**RFB NO. 313083 - ADDENDUM NO. 1**

**CONSTRUCTION OF EAST HIGHWAY GARAGE – SALT  
STORAGE FACILITY (BID PACKAGE A) AND  
MEDICAL EXAMINER OFFICE BUILDING (BID PACKAGE B)**

**DEPARTMENT OF PUBLIC WORKS,  
HIGHWAY & TRANSPORTATION  
3562 COUNTY HIGHWAY AB  
MCFARLAND, WISCONSIN**

1 ROOF FRAMING PLAN  
SCALE: 1/8" = 1'-0"

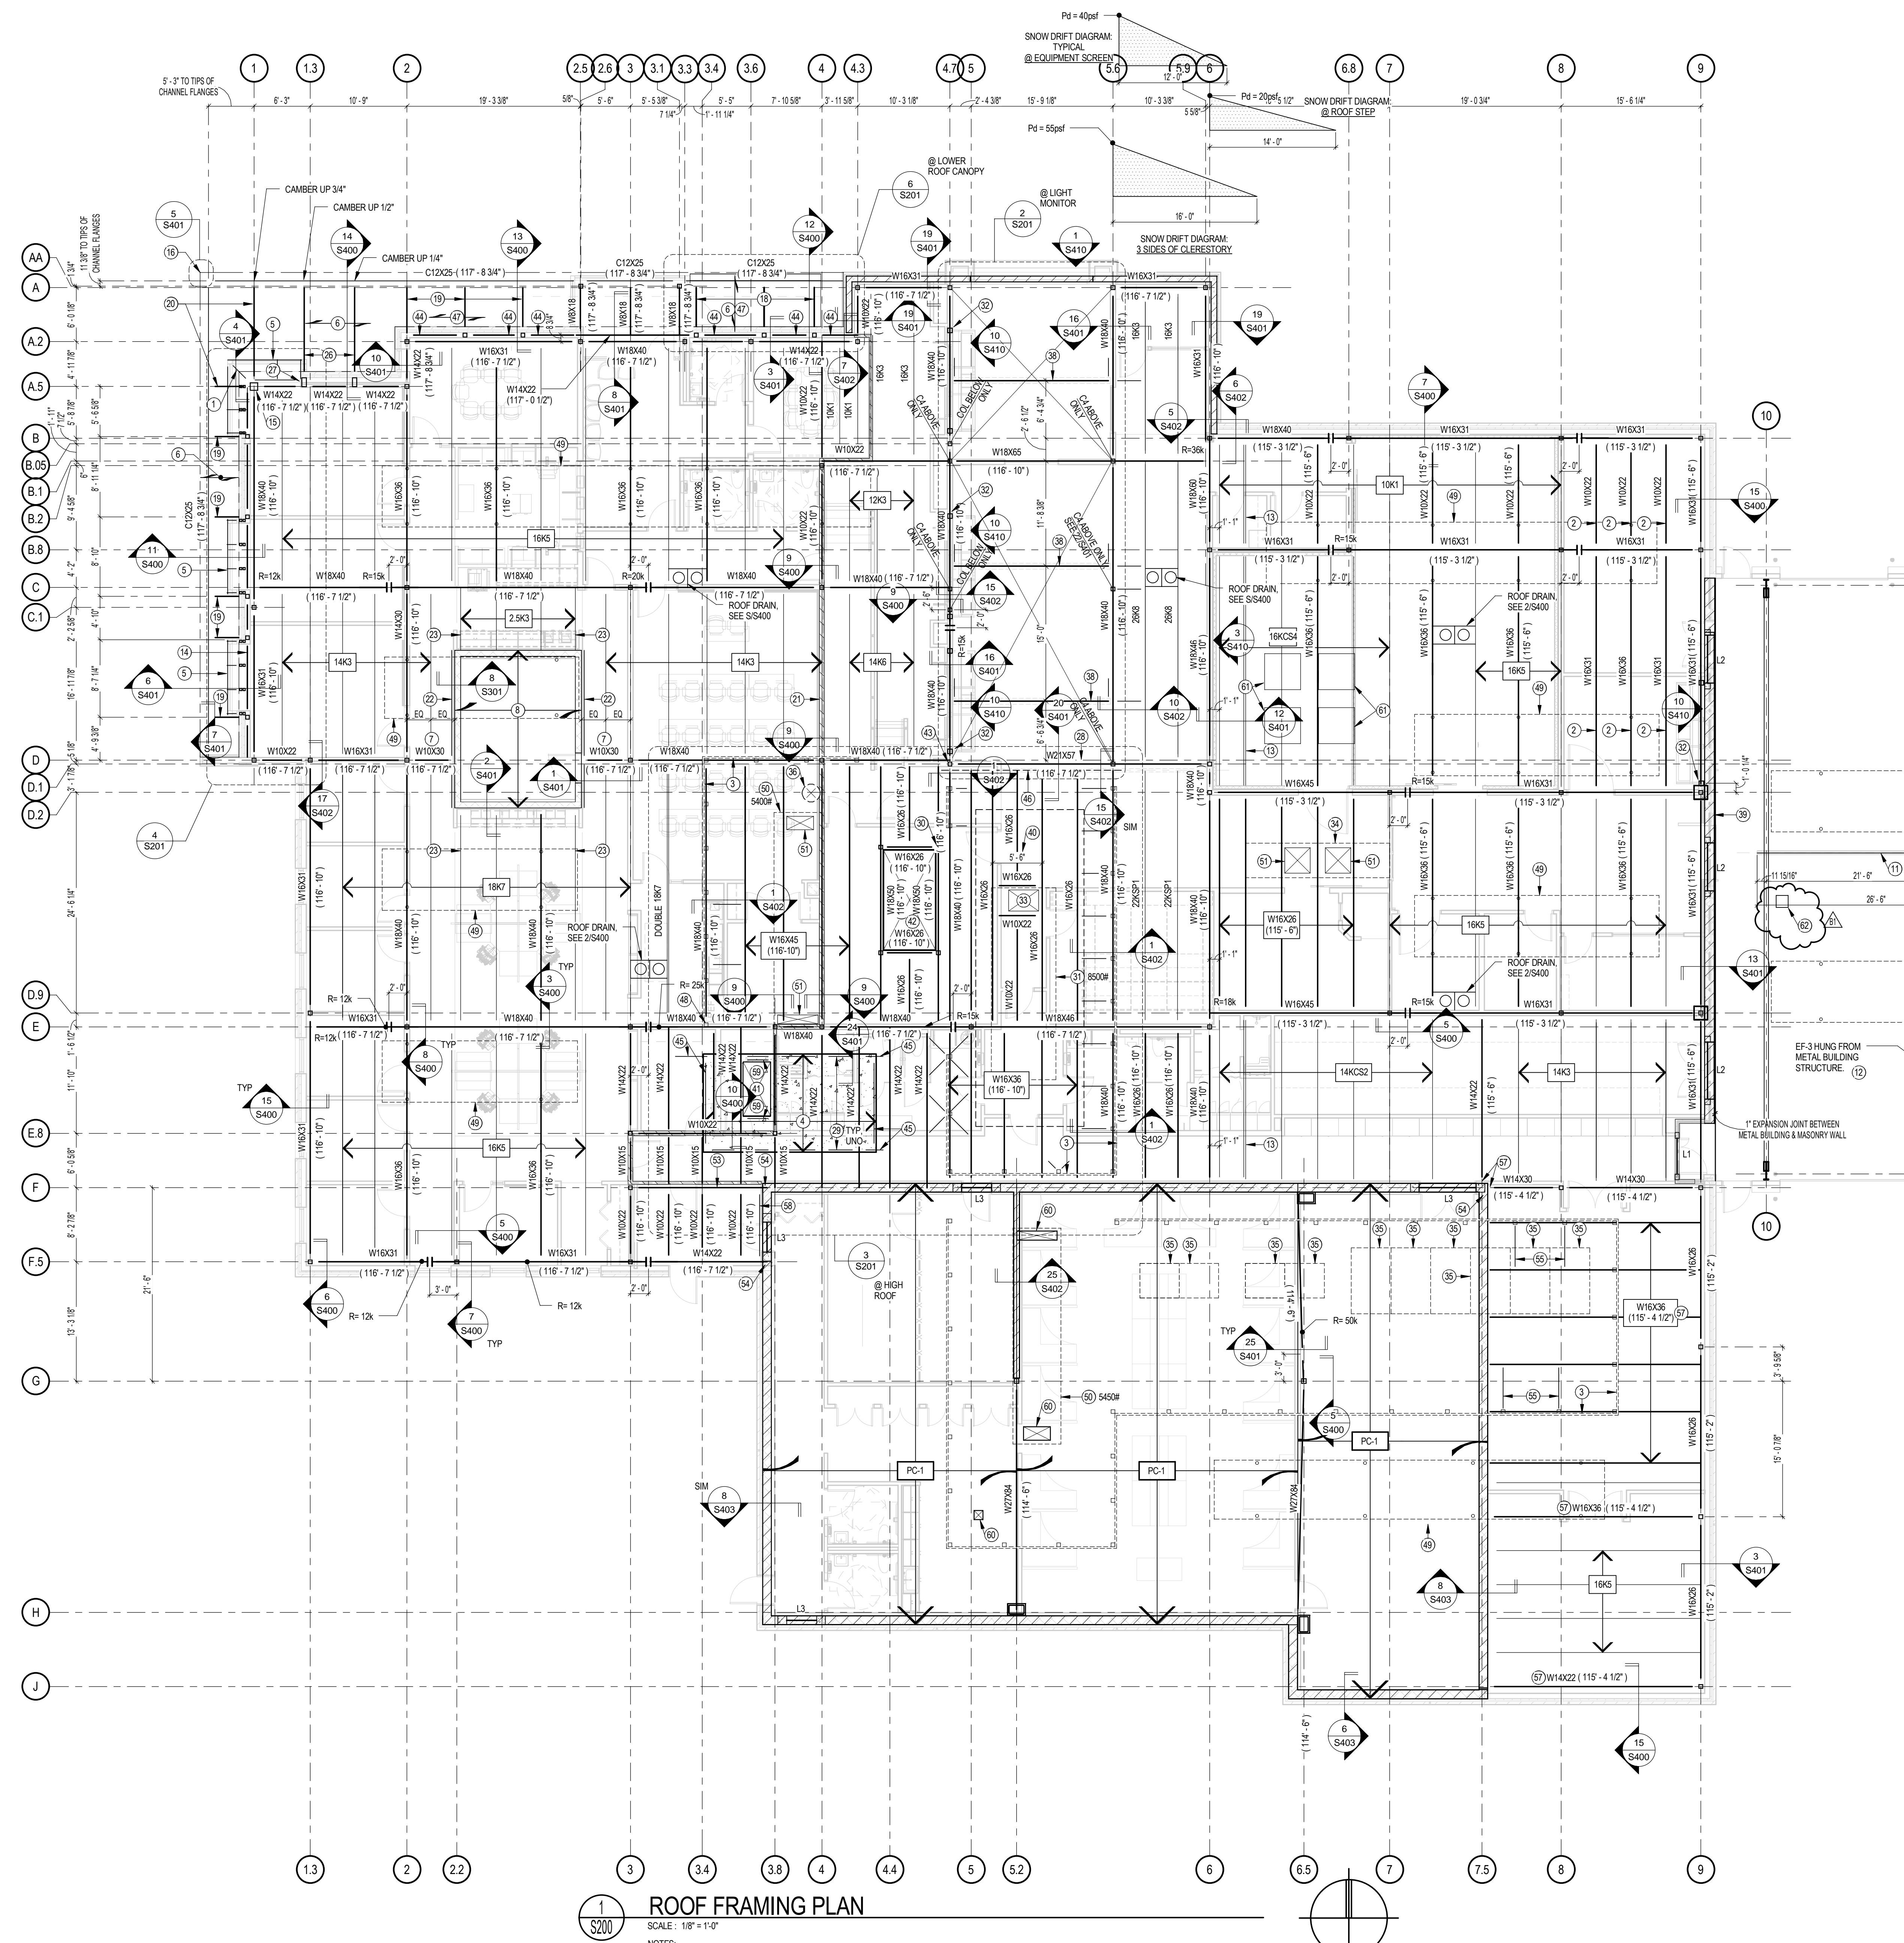
- e. Keyed Notes: Revised note 1. Added notes 21,22.
52. SHEET S200:
- a. Replace in its entirety.
  - b. Detail 1/S200: Added unit weight for EF-4 in the Garage building.

- c. Detail 1/S200: Added note 62 to garage plan noting the location of cord reel supports.
  - d. Detail 1/S200: Added note 63 to garage plan noting the roof deck at the garage.

- e. Detail 1/S200: Added note 4 to the “Notes for Framing of Pre-Engineered Metal Building Garage”.
  - f. Keyed Notes: Revised note 49. Added notes 62,63.

**1** PLUMBING UNDERFLOOR PLAN  
P100 SCALE: 1/8"=1'-0"  
NORTH

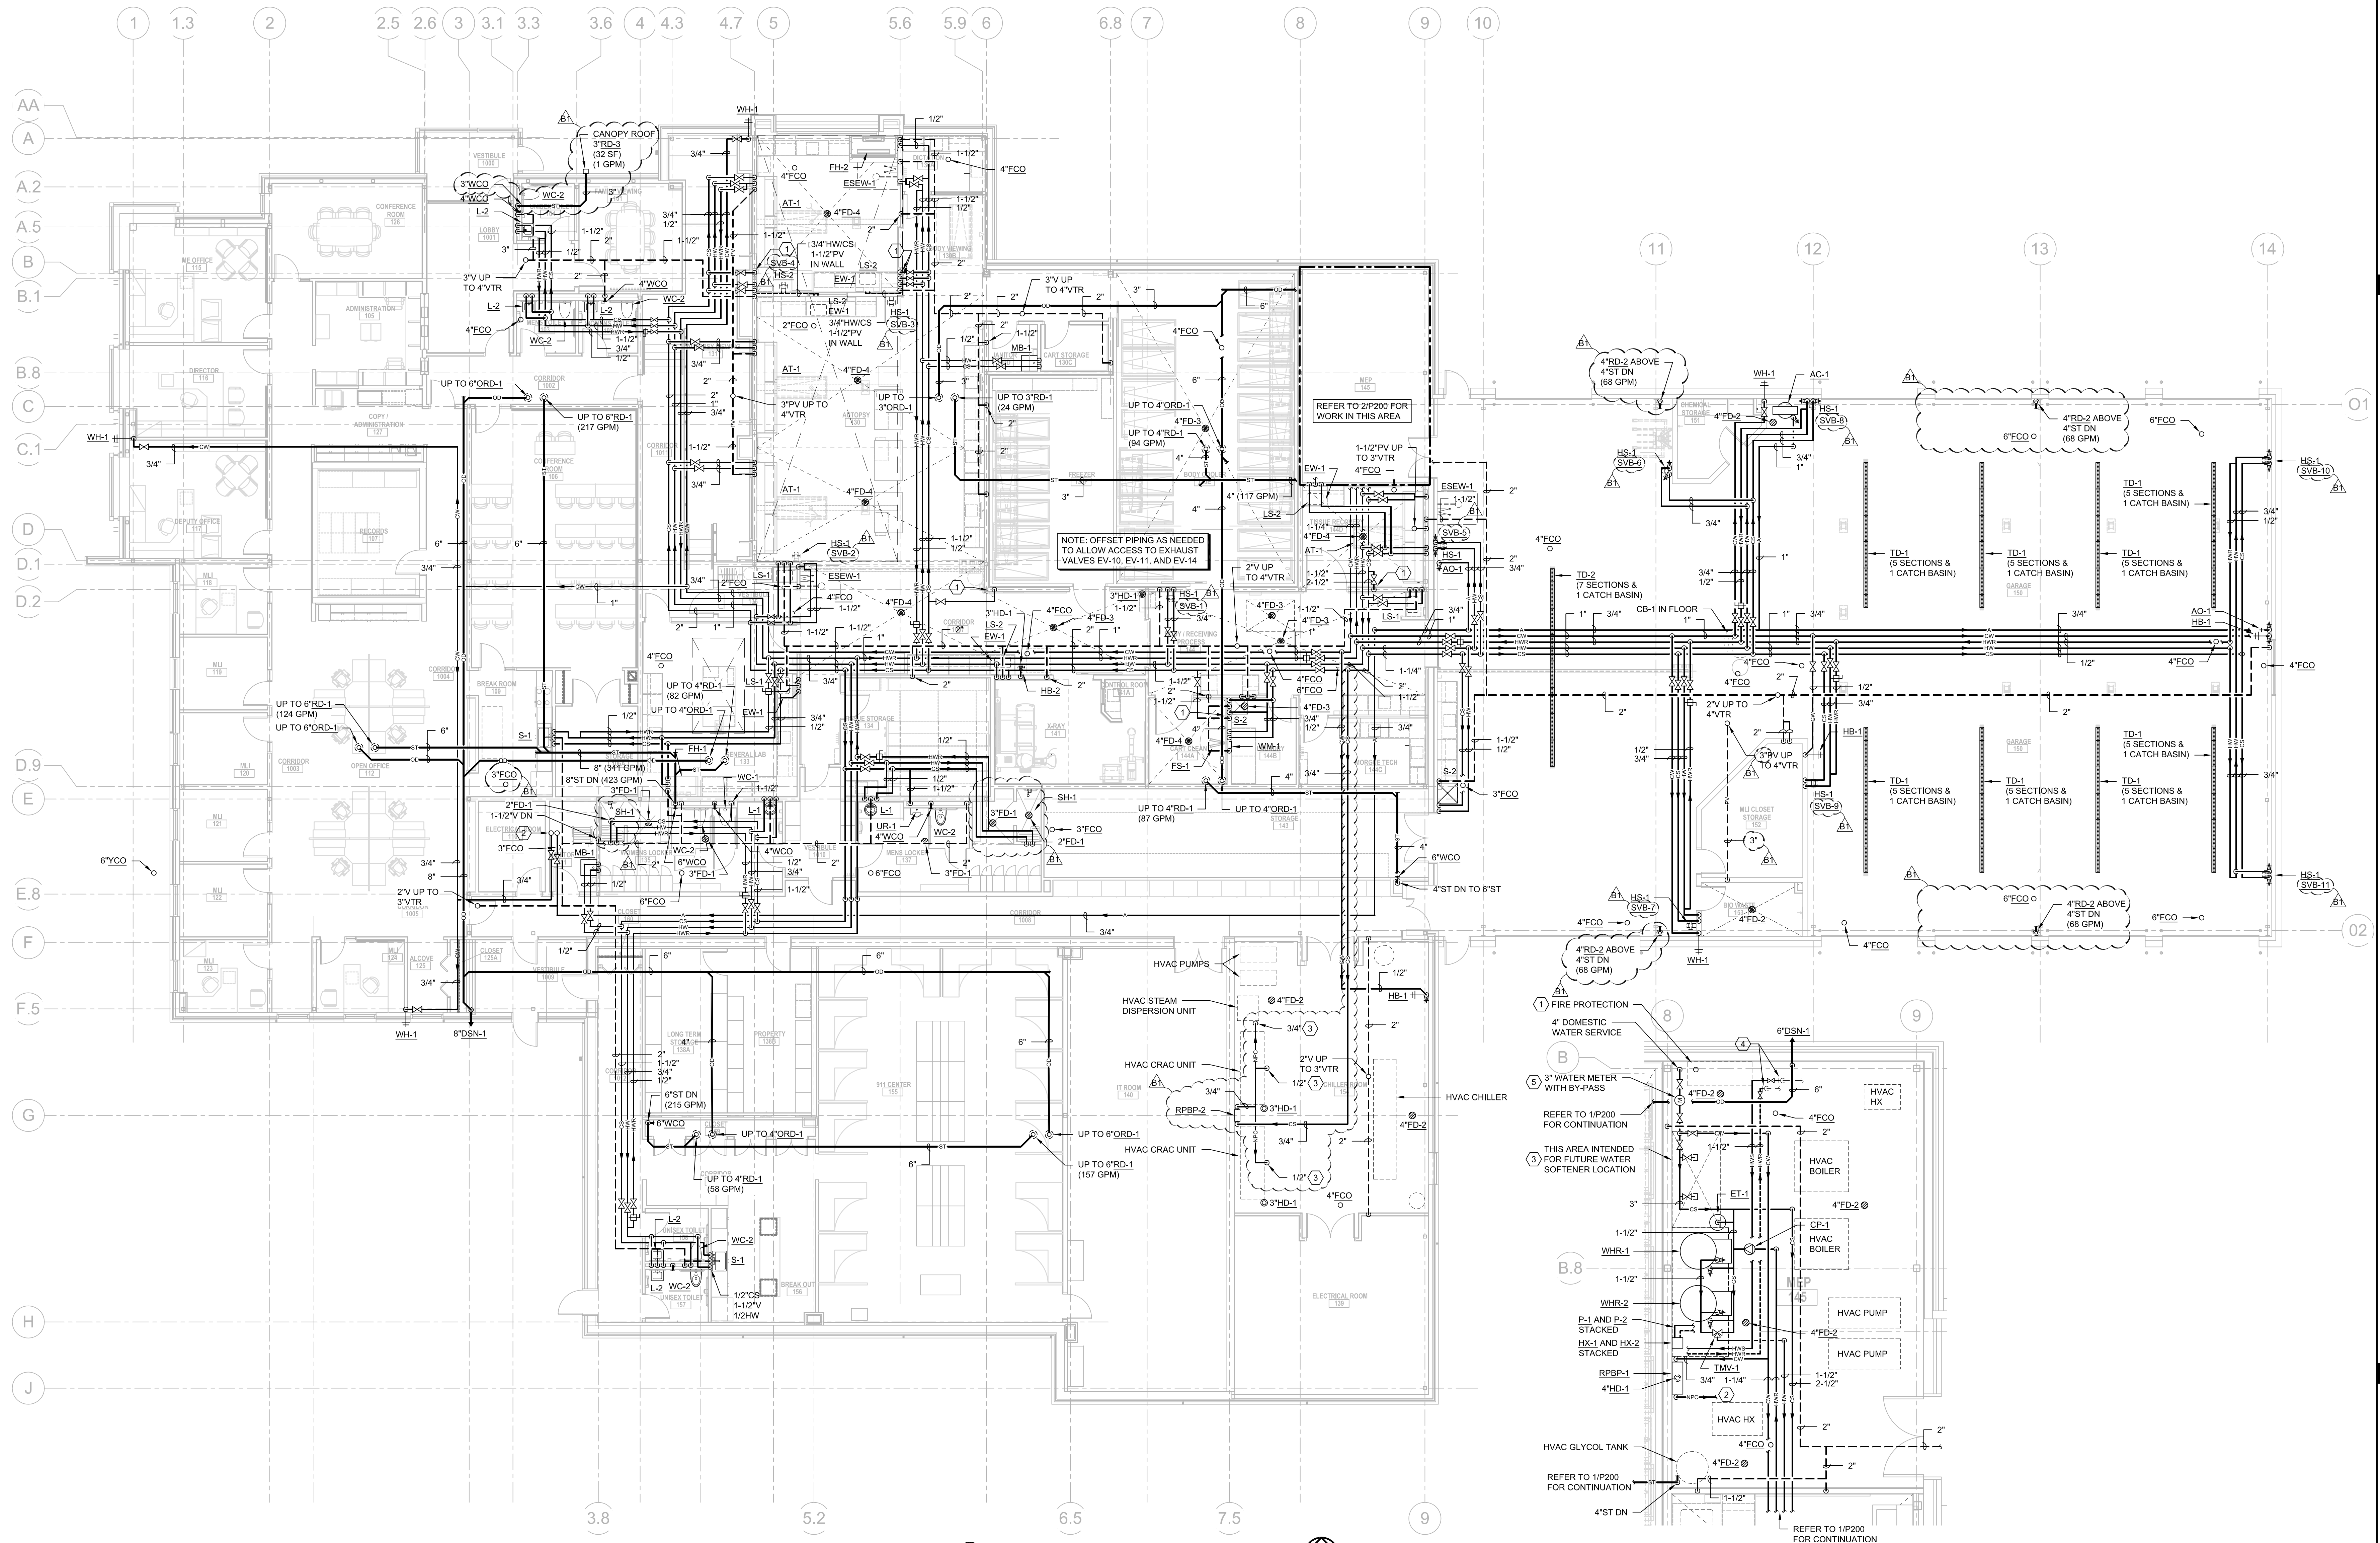
57. SHEET P100:
- a. See revised drawing, P100, attached.
58. SHEET P200:
- a. See revised drawing, P200, attached.
59. SHEET P701
- a. See revised drawing, P701, attached.
